Intel[®] 80321 I/O Processor

Specification Update

May 12, 2003

Document Number: **273519-010**

Figure 2. Power Fail State Machine

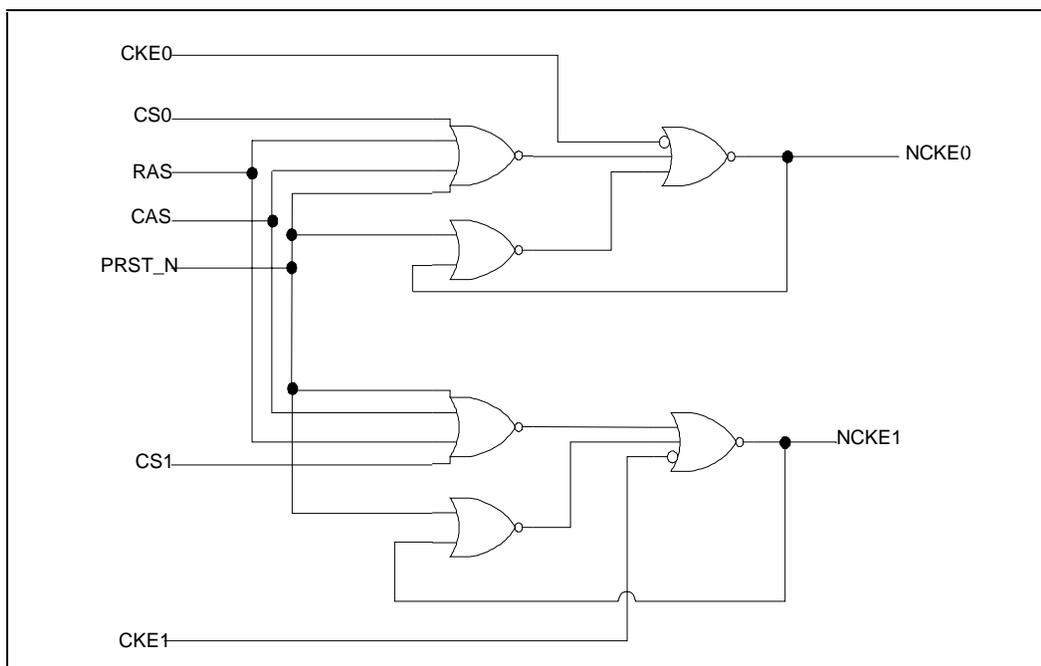
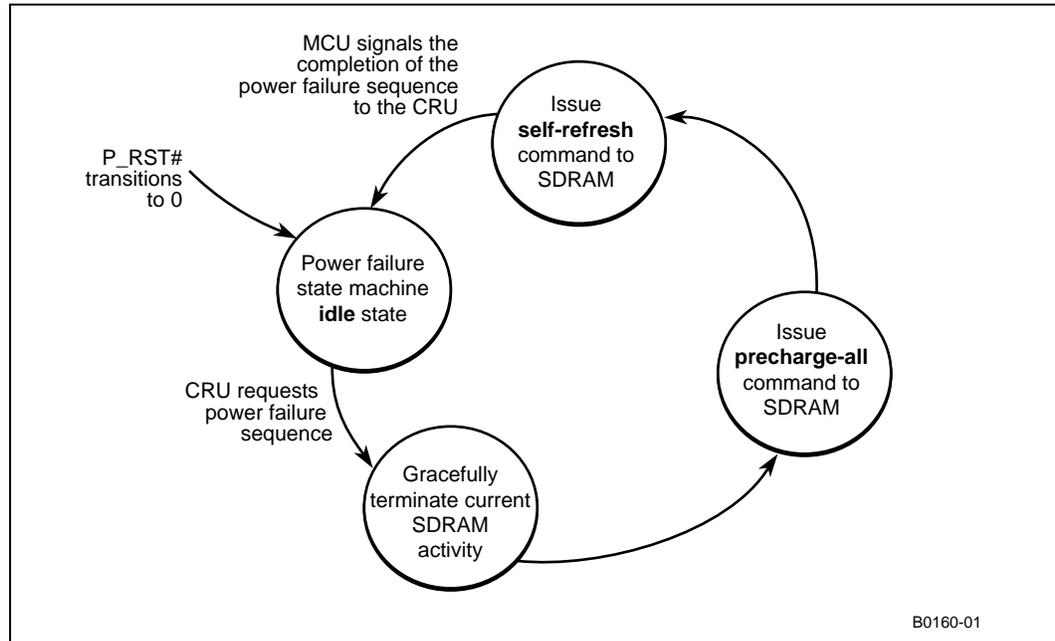
The minimum clock count between the auto-refresh command and the self-refresh command is eight clock cycles, to allow enough time for the DDR state machine to complete the auto-refresh command in the power fail sequence. The problem is that the number of clock cycles between these two commands is only four clock cycles. Therefore, the self-refresh command is not recognized by the DDR state machine, because the DDR state machine is still executing the auto-refresh command. Since the self-refresh command is missed by the DDR state machine, the DDR never enters self-refresh mode. Therefore, DDR memory data integrity cannot be guaranteed.

Workaround: Convert the auto-refresh command, during the power fail sequence, to a self-refresh command and to hold the SCKE[1:0] signal low until the POR# pin is deasserted. The circuit for this workaround is shown below. This circuit also provides the workaround for Item 7. PLD equations for this circuit are available upon request.

10. PLL Unable to Lock at Reset

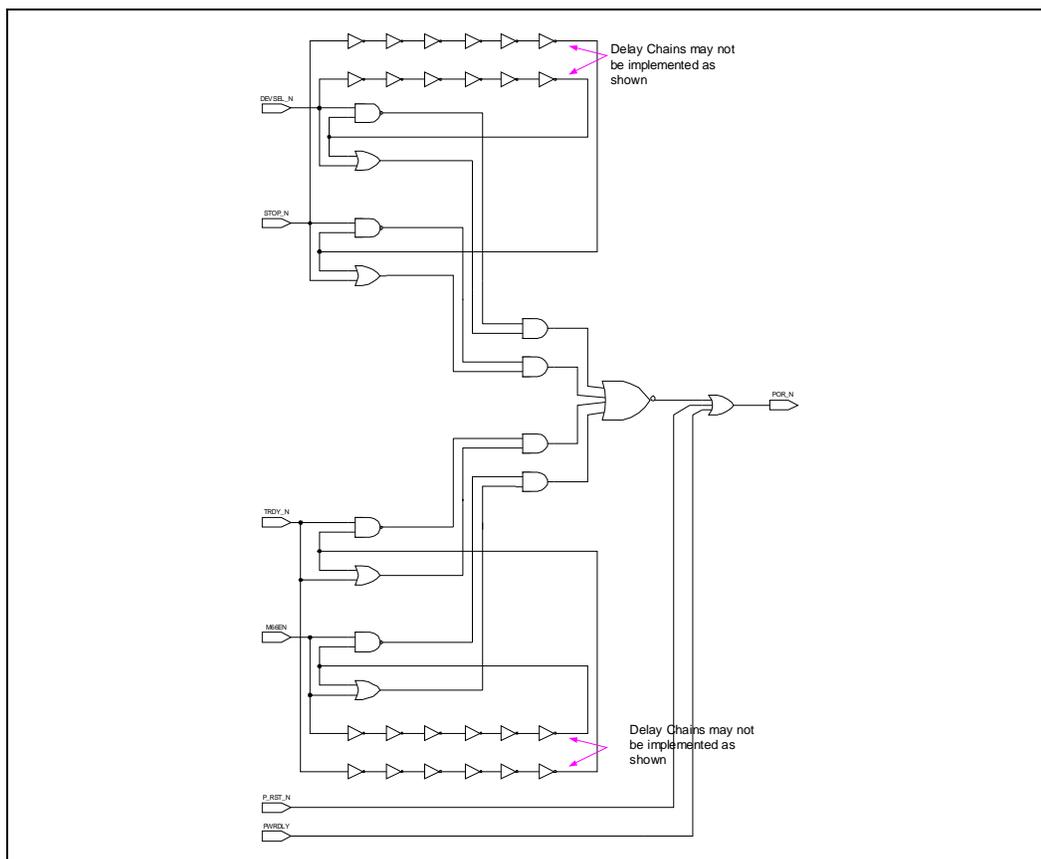
Problem: The combination of FRAME#, IRDY#, DEVSEL#, STOP# and TRDY# signals, provide the PCI-X initialization pattern at the rising edge of P_RST#, per Table 6-2 in the *PCI-X Addendum to the PCI Local Bus Specification*, Rev. 1.0a. The PCI-X initialization pattern needs to have been in a known state for a minimum of 10 clock cycles, before the rising edge of P_RST#, to ensure the stability of the PCI-X initialization pattern.

Workaround: Pulse the POR# signal once the PCI-X initialization pattern frequency matches the P_CLK, before the rising edge of P_RST#. An example circuit for this workaround is shown in the following diagram. PLD equations for this circuit are available upon request. The function of this circuit is to pulse the POR# pin when there is any change in the PCI-X initialization pattern, prior to the deassertion of P_RST#. A pulse width of approximately 200 ns is required. This allows the PLL to reset and latch the correct PCI-X initialization pattern to ensure proper PLL operation upon coming out of Reset.

Figure 1. Partial Memory Initialization Examples

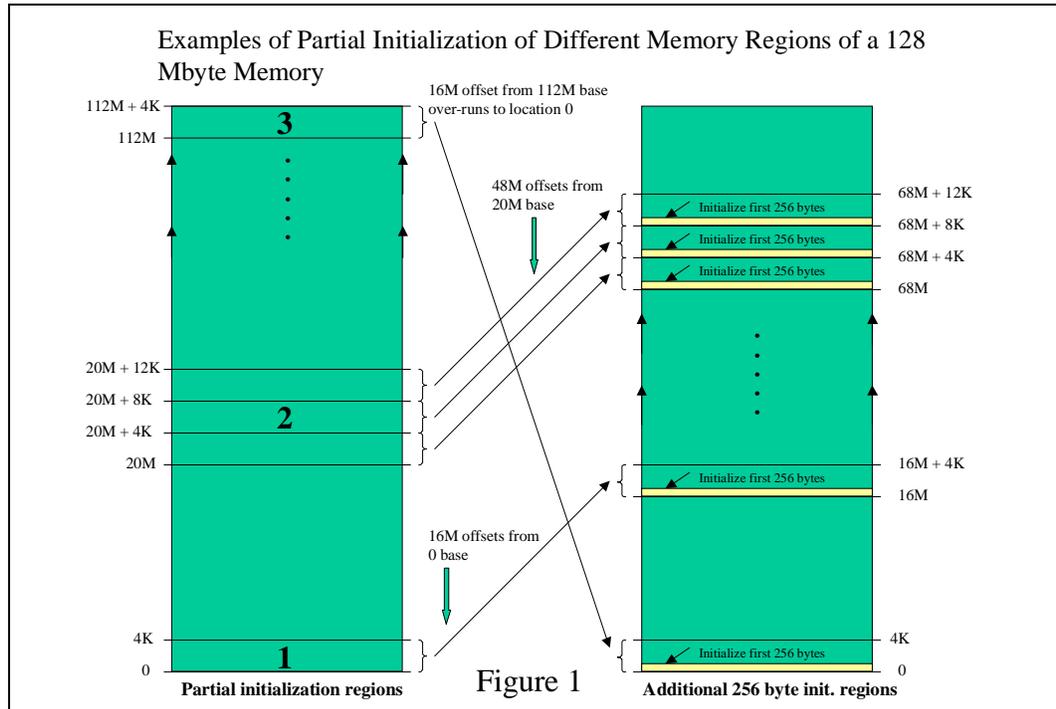
1. The useable space must be a multiple of 4 Kbyte blocks.
2. All column addresses associated with each used 4 Kbyte block requires the first 256 bytes of the matching 4 Kbyte offset block to also be initialized. The offsets for each of the following examples are derived from the column addressing scheme for the 80321 DDR SDRAM Addressing. Refer to section 7.2.2.2, “DDR SDRAM Addressing”, in the *Intel® 80321 I/O Processor Developer’s Manual*, for an explanation of 80321 column addressing.

Figure 2. IOP321 P_BMI Signal Implementation for 80321 B-0/B-1 Stepping

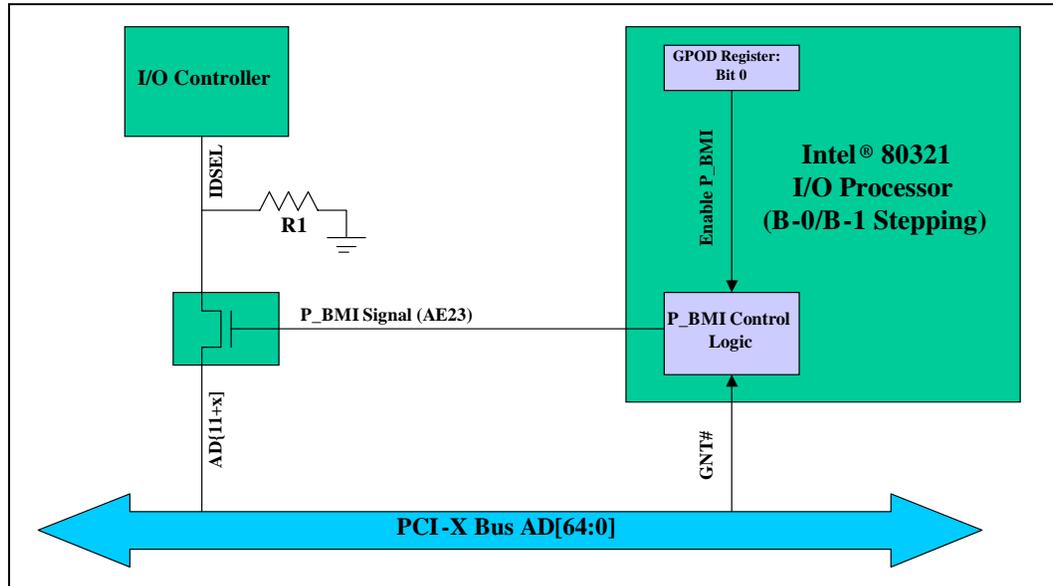
The P_BMI (AE23) signal has been added to the Intel® 80321 I/O processor (B-0/B-1 Stepping). This signal replaces, using an external GPIO pin for Initialization Device Select (IDSEL) control of an I/O device during host configuration cycles.

The IDSEL signal is used as a chip select during configuration cycles initiated by the BIOS, operating system or 80321. The GPOD[0] can be driven low in firmware, thereby disabling the P_BMI signal and hiding the host I/O device from the system, by turning off its IDSEL. When the 80321 intends to perform configuration cycles in the PCI bus segment of the I/O device, the P_BMI signal should be asserted high by driving the GPOD[0] high. The affect of these two operations is, that the I/O device is initialized and controlled by the 80321. More care must be taken with the gate chosen to control IDSEL, since most host bridge controllers do not use PCI address stepping. With IDSEL being a synchronous signal, with respect to CLK, the switch used must be a sub nanosecond propagation delay device (e.g., Pericom PI5C3303). In Figure 2, the P_BMI signal is used to control a mux/demux switch that is used to enable/disable IDSEL to the I/O device.
